TECHNO-ECONOMIC ASSESSMENT STUDY FOR ROGUN HYDROELECTRIC CONSTRUCTION PROJECT

PHASE II: PROJECT DEFINITION OPTIONS

Appendix 5: PMF Management

Report No. P.002378 RP 55 rev. D

Figure 3-1 : Extract of HPI study - 3rd operation spillway - longitudinal section

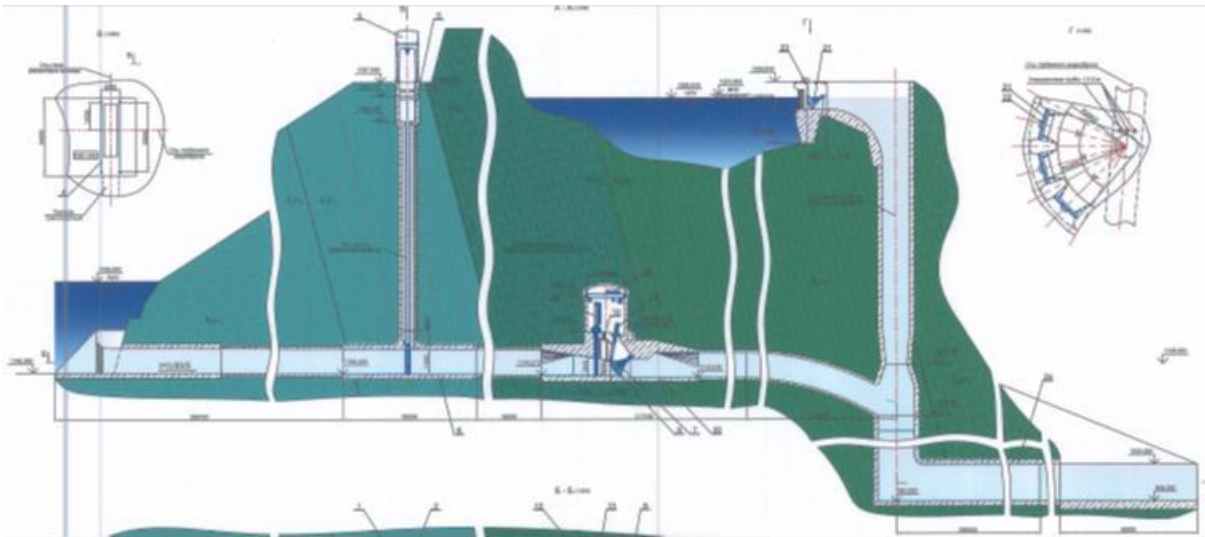
- 3rd operation spillway (OP3): it is a tunnel spillway with intake at elevation 1145 masl, some 400 and 600 m long, it splits into 2 branches. Each branch includes a vertical vortex shaft ended with a vortex device that dissipates a large part of the energy. The final tunnel stretch is horizontal and ended with a flip bucket set up a few meters above the river. (see Figure 3-1)

- Two of the three spillways are sharing the same outlet tunnel. A failure of the upstream stretch will impact two of the three tunnels, i.e. 50% of the total discharge capacity.

- Although the solution with tunnel spillways with a vortex device for energy dissipation is a good option for the energy dissipation and has been implemented on some dams across the world, there is no reference for such a large design flood. The only comparable devices have been implemented in Tehri (India) with capacities of 1900 m³/s and 1950 m³/s as described in the Volume 3, Chapter 3, Appendix 4 “Hydraulics of the project components”. Since commissioning it has operated only once, for a discharge of 480 m³/s as it is not the main spillway facility. In Tehri, there is also a classical surface spillway with a chute channel, flip bucket and stilling basin, that ensures 40% of the total discharge capacity. Relying on vortex devices only for permanent spillway facilities with such a large capacity is not considered as a safe concept by the TEAS Consultant.

- Maximum head on the tunnels beyond the value recommended by the Consultant.
- Necessity to re-design the distribution of flow between spillways in order to meet the N-1 criterion.
- Two devices sharing the same outlet.
- Lack of experience for such high capacity of vortex facilities for permanent flood evacuation facilities.
- Long term flood discharge facilities are not provided in HPI design.

The Consultant considers that safety requirements are not met. Therefore, other options are studied in the rest of the present appendix in order to select the appropriate solution for each dam height.

Figure 3-3: Extract of HPI study - Spillways discharge capacity versus reservoir elevation

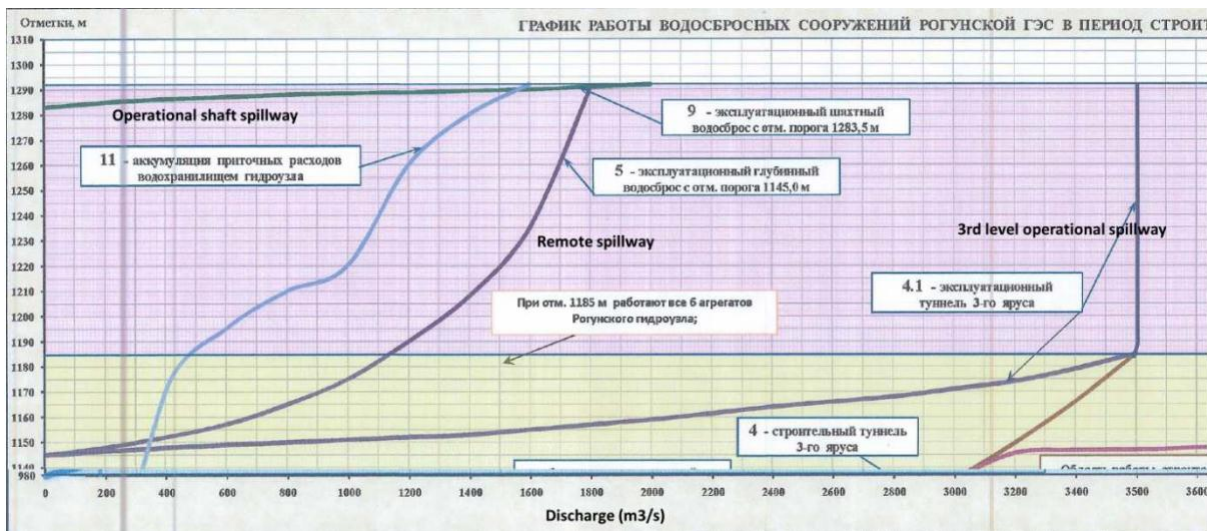
The solution proposed by HPI provides a protection against the PMF and should be able to pass the new value of the PMF, that is to say 7 800 m³/s. However, when the spillway is used during the flood season, the head on the tunnels is 145 m. This value is higher than the maximum head considered acceptable by the TEAS Consultant as presented in the Appendix 3 “Flood Management during Construction” in Chapter 3 “Alternatives Design” that is to say 120 m.

The N-1 criterion for the 10 000 years return flood can be met with three spillways. However, with the current design proposed by HPI, without the 3rd level Operational spillway, the 10 000 years return flood cannot be handled in Rogun: the operational shaft spillway can discharge up to 2000 m³/s and the remote spillway 1800 m³/s.
